802.3dj D3.1

Comment Resolution

Common Topics

Matt Brown (Qualcomm), 802.3dj Chief Editor
Leon Bruckman, Nvidia

Figure 178B-10b—Training control state diagram, part 2

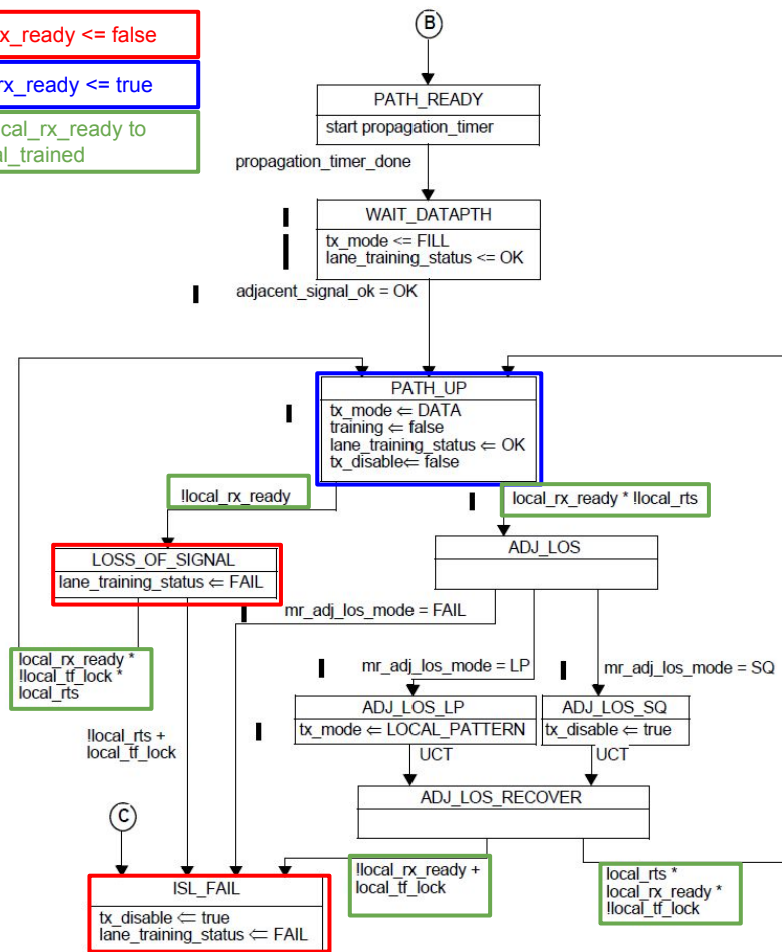
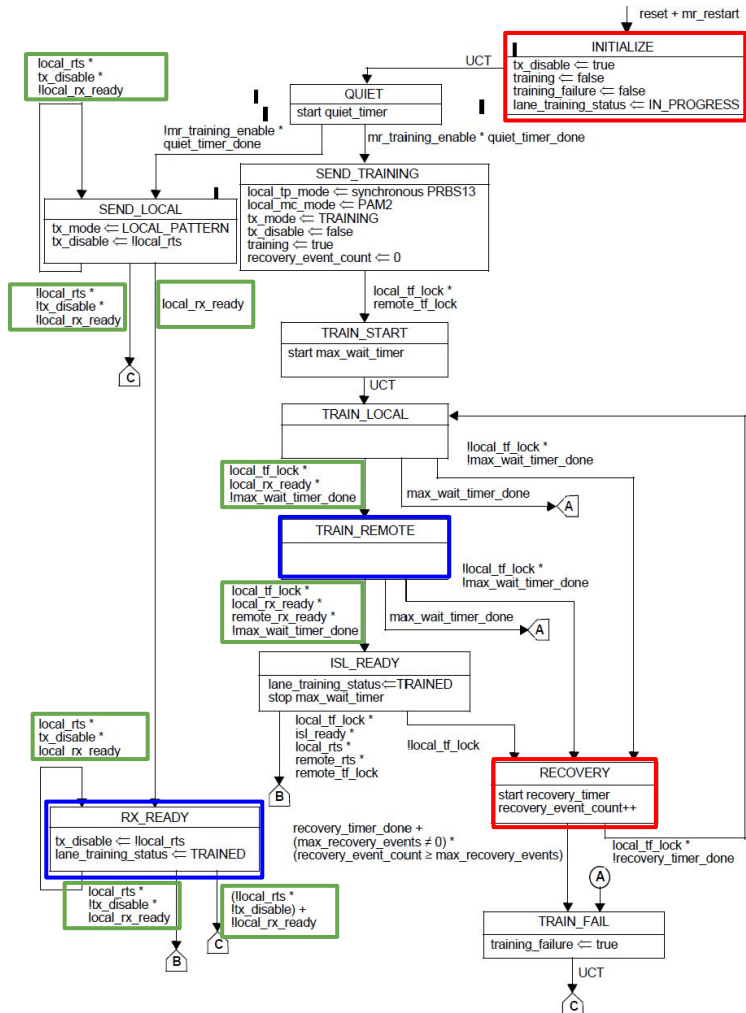
Cl 178B	SC 178B.8.3.1	P898	L11	# R1-188
Slavick, Jeff		Broadcom Inc		
Comment Type	TR	Comment Status	D	State diagrams (CA)
Stating that variable takes on a particular value in a given state diagram state means its value should be set by the state diagram.				
In Figure 136-7 local_rx_ready is a variable set in the state diagram and depends upon a local_trained variable.				
We should take on this same format for 178B-10				
SuggestedRemedy				
Rename local_rx_ready to local_trained and remove the last sentence of the current definition.				
Create a new definition for local_rx_ready with a definition of "Boolean variable that indicates the state of the receiver. The value of local_rx_ready is set by the training control state diagram (Figure 178B-10a and Figure-10b).				
In Figure 178B-10a and 10b replace all current instances of local_rx_ready with local_trained				
In Figure 178B-10a add "local_rx_ready = false" to the INITIALIZE and RECOVERY states.

In Figure 178B-10b add "local_rx_ready = false" to the LOSS_OF_SIGNAL state.				
In Figure 178B-10a add "local_rx_ready <= true" to TRAIN_REMOTE and RX_READY states.				
In Figure 178B-10b add "local_rx_ready <= true" to PATH_UP state.				
Proposed Response		Response Status W		
PROPOSED ACCEPT IN PRINCIPLE.				
Implement with editorial license.

local_trained

~~local_rx_ready~~

Boolean variable that is set to true when the receiver on a lane of the interface has determined that the peer interface transmitter is transmitting the expected signal format, that the remote transmit has been optimized if mr_training_enable is true, that the local receive equalizers have been optimized, and that no further adjustments are required for normal data transmission. The specific conditions for setting this variable to true are implementation dependent. It shall be set to false when an input signal corresponding to tx_disable = true in the peer is received for 100 ms (the minimum duration of the quiet_timer) or longer. ~~When in the RECOVERY state (Figure 178B-10a) this variable is false.~~

New

local_rx_ready

Boolean variable that indicates the state of the receiver. The value of local_rx_ready is set by the training control state diagram (Figure 178B-10a and Figure-10b).
